Subject: Service Bulletin 159-047-00, Rev. 0 for Electric Swivels

SERVICE BULLETIN

Subject: Electric Swivels & Potential for Severe Long Line Twist

Document: 159-047-00

Figure 1 – Worn Bearing Race

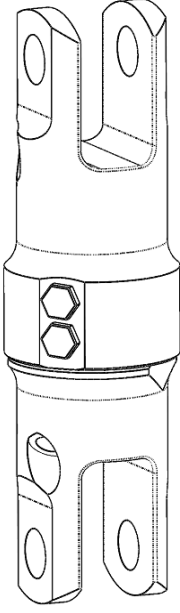
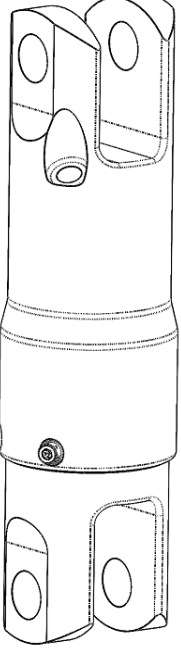
Description of Incident: Onboard Systems has been notified of a failure of a synthetic long line while utilizing a P/N 232-457-00 Electric Swivel. Investigation indicated a contributing factor to the line failure as excessive twist. Severe twist in a loaded long line may lead to reduction of its breaking strength—partly by decreasing the effective number of load-bearing strands. Under-rotation of the 232-457-XX Electric Swivel likely resulted from an over-worn bearing race, possibly aggravated by lack of preventive maintenance.

If the feel of the swivel is not smooth, disassemble per instructions in Owner's Manual 120-205-00. Clean bearing races and examine under magnification. If roughness, denting, or fretting is observed, discontinue use and retire the unit from service. No repair regimen is possible to recondition the integral bearing races. See Figure 1.
